2. Item 1A

Appeal of Planning Commission Resolution No. 26-05 Regarding Coastal Development Permit No. 19-012 (25200 Pacific Coast Highway, APNs 4459-013-021 and 4459-014-018; Owner, PAR PCH, LLC; Appellant, Jun Hall for Concerned Citizens of Malibu Road, Inc.)

Amended[1] Malibu City Council
Special Meeting Agenda

Very FAR OFF the required 1.5 static factor of safety

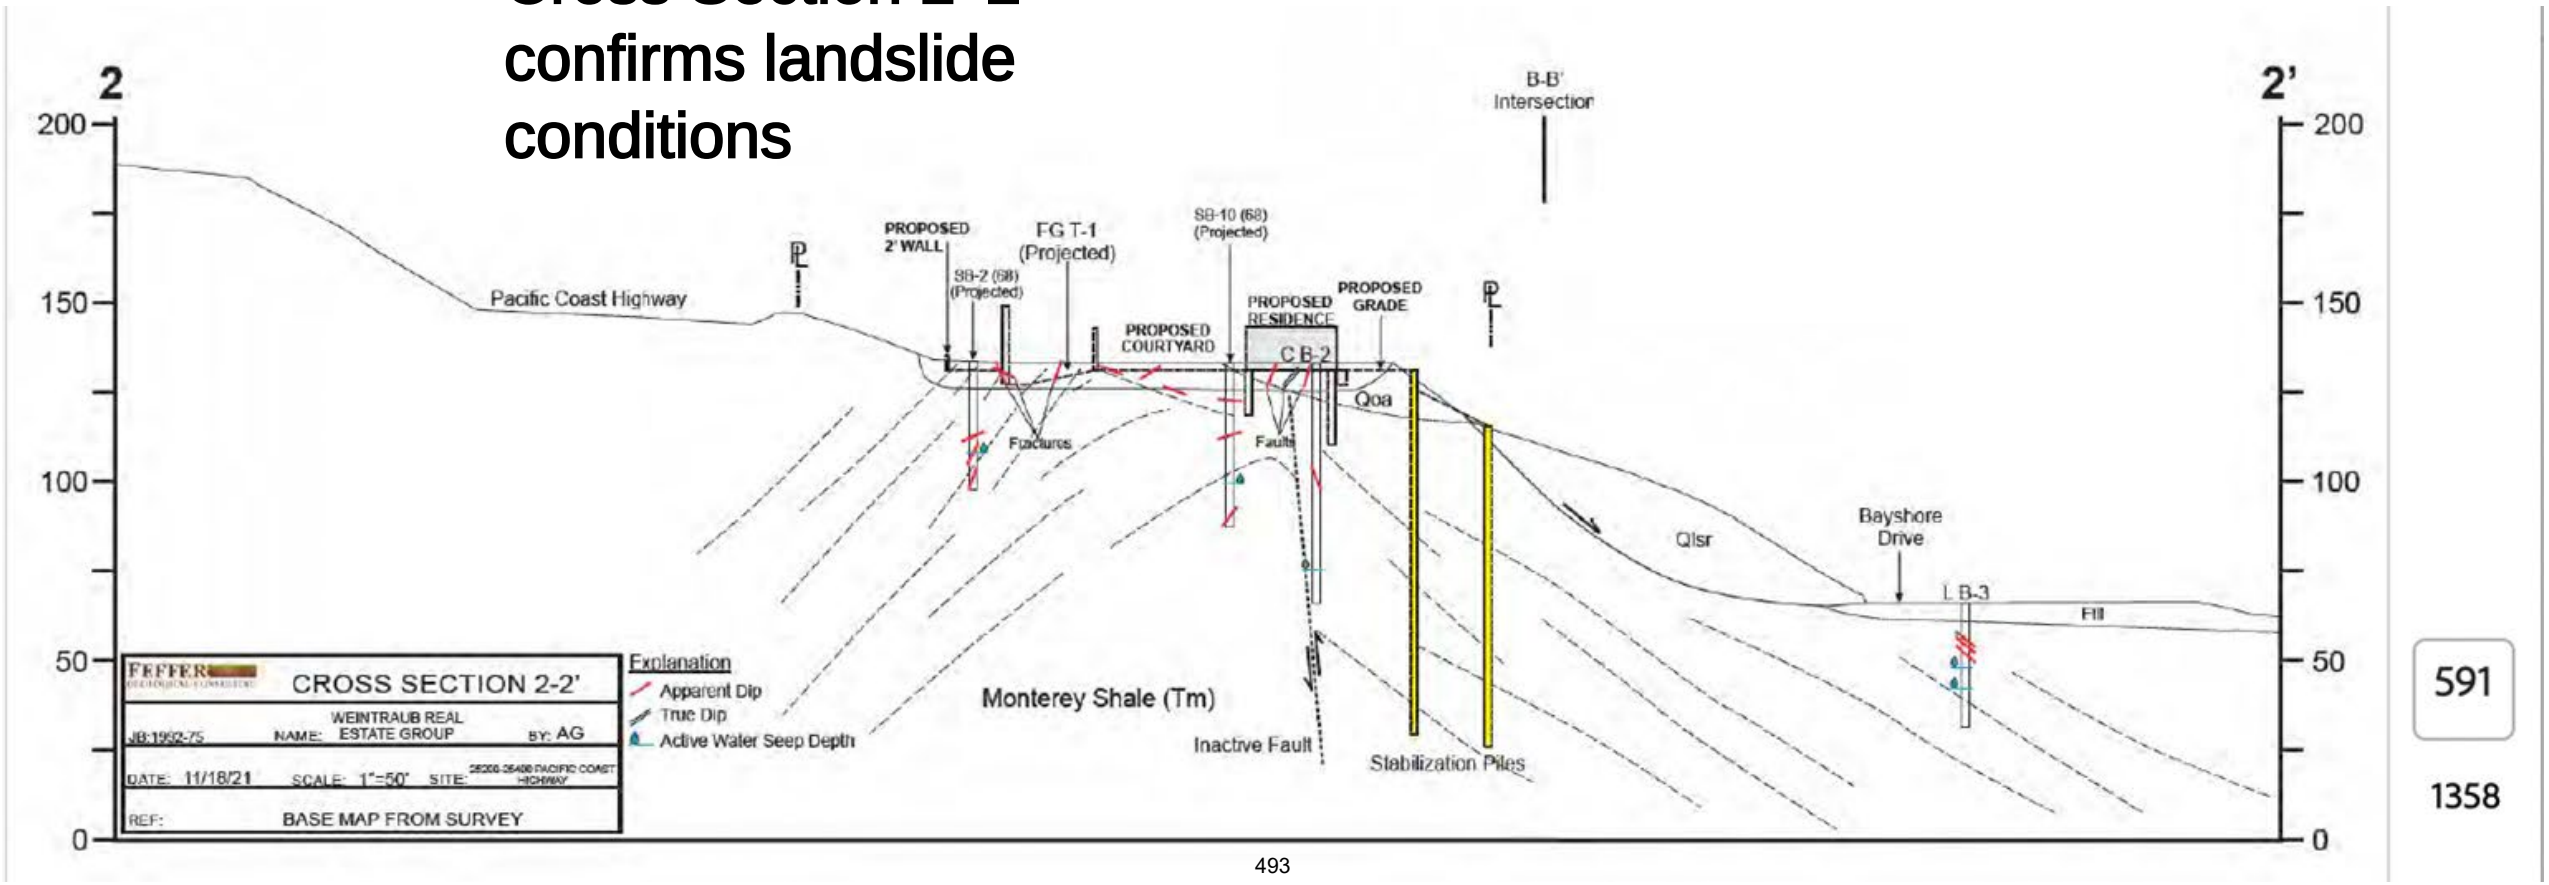
- Required minimum (LIP §9.4(D)): **1.5 static**
- Calculated results: **1.076 - 1.234**
- Values near **1.0 = marginal equilibrium / instability**

Pile Base Elevation vs Slide Base Elevation

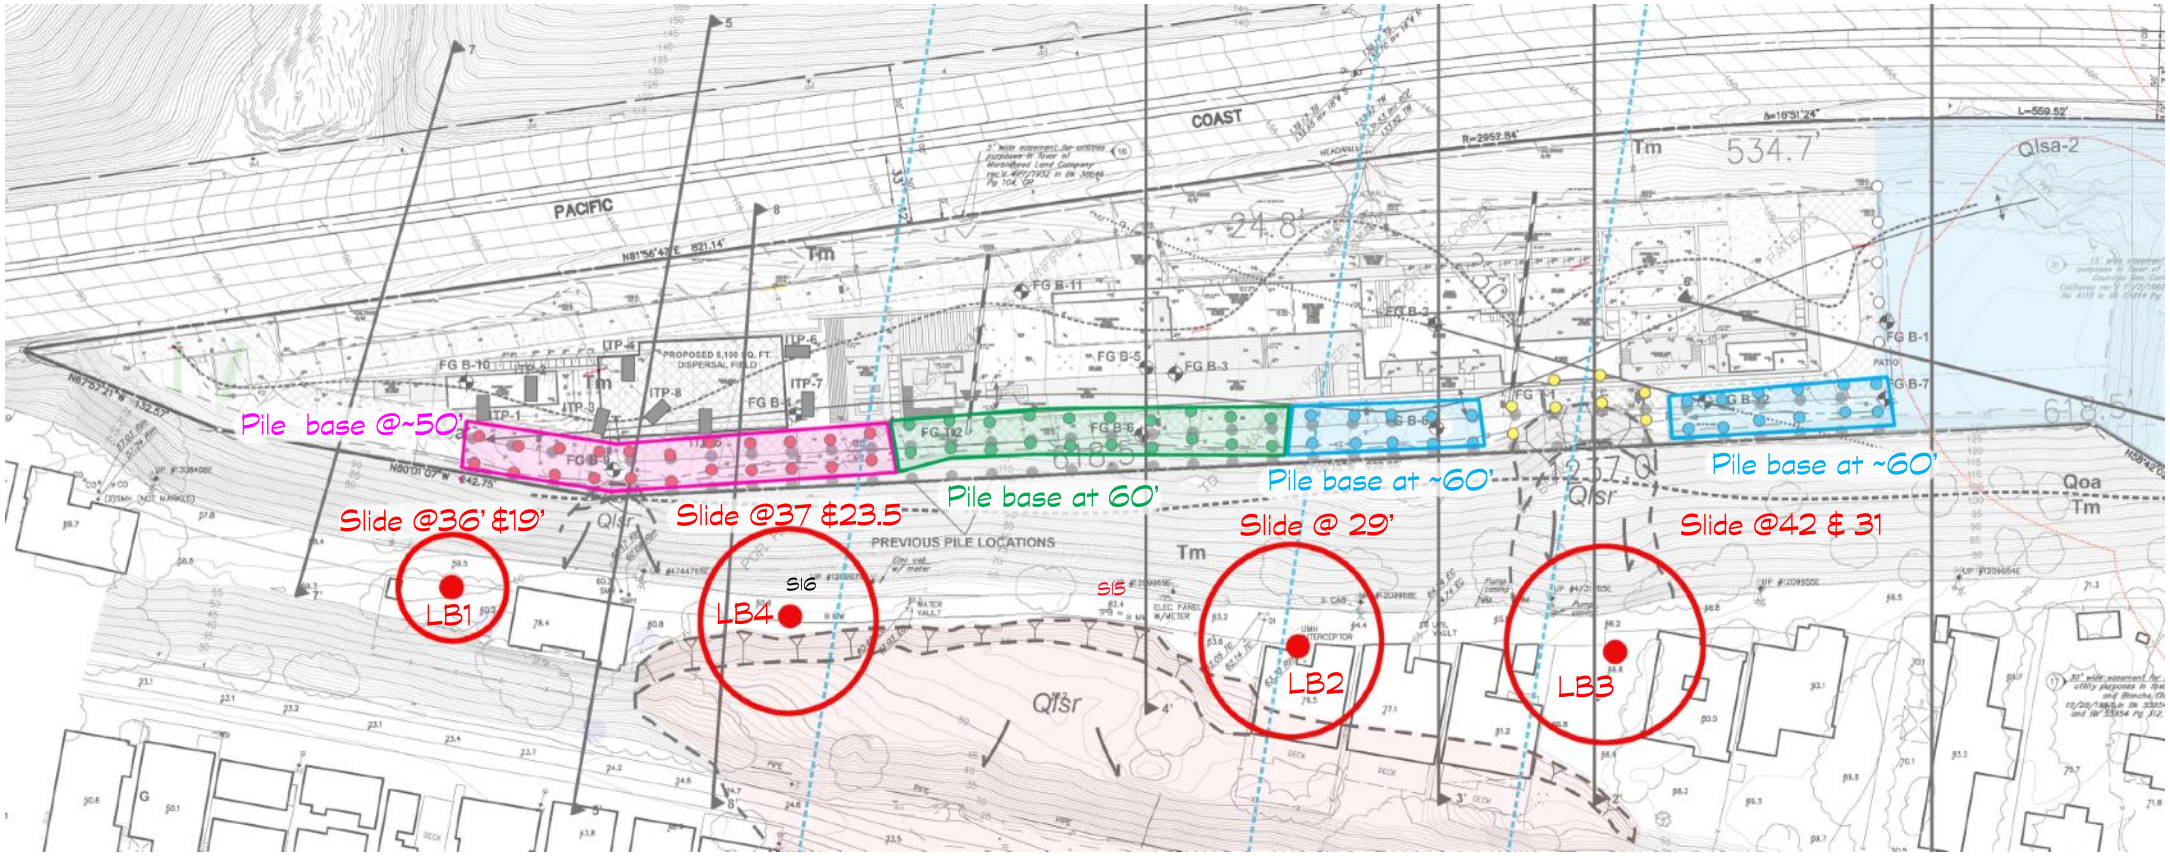
Pile color from map	Red	Green	Blue and Yellow
Depth/pile length	50’	60’	60’
Bottom elevation of pile	50’	60’	60’
Slide Plane Elevation	36’& 19’/37’23.5	37’-29’	29’-31’
Deficit	14’ to 31’	36.5’-31’	31’-29’
